**AMENDMENTS TO THE DRAWINGS**

Replacement Sheet  
Q65519 Giovanni TRAVERSO  
USSN: 09/911,625 Art Unit: 2633  
Conf. No.: 3452 For: VIRTUAL  
CONCATENATION OF OPTICAL...  
(202) 293-7060 1/4

FIG. 1

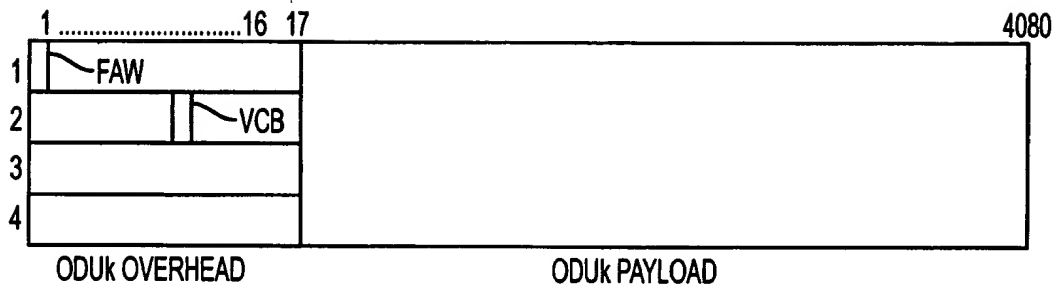
Figs. 1-3 have been amended to coincide with MPEP 608.02.

FIG. 4

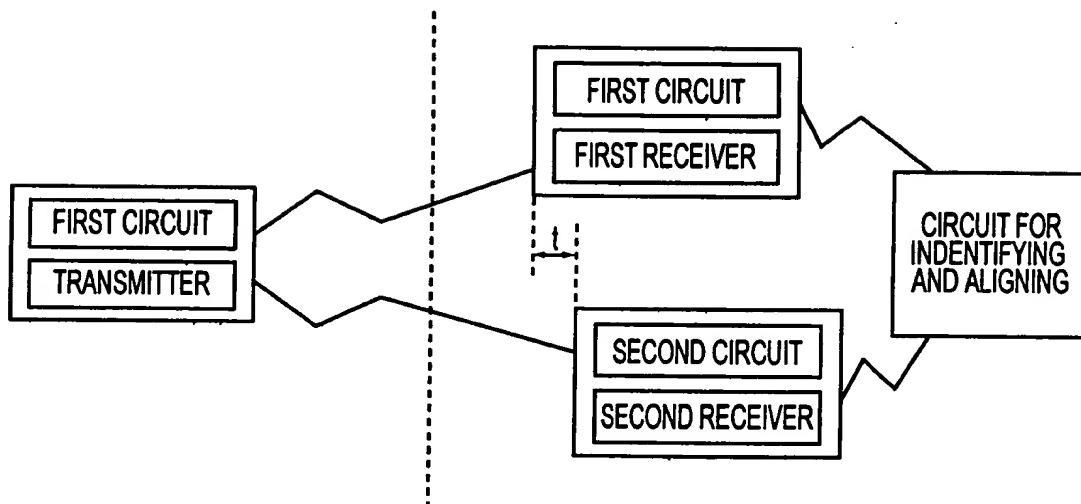
Fig. 4 has been added to illustrate the first circuit and transmitter of claim 6 and the first receiver, first circuit, second receiver, second circuit and circuit for identifying and aligning of claim 7. No new matter has been added.
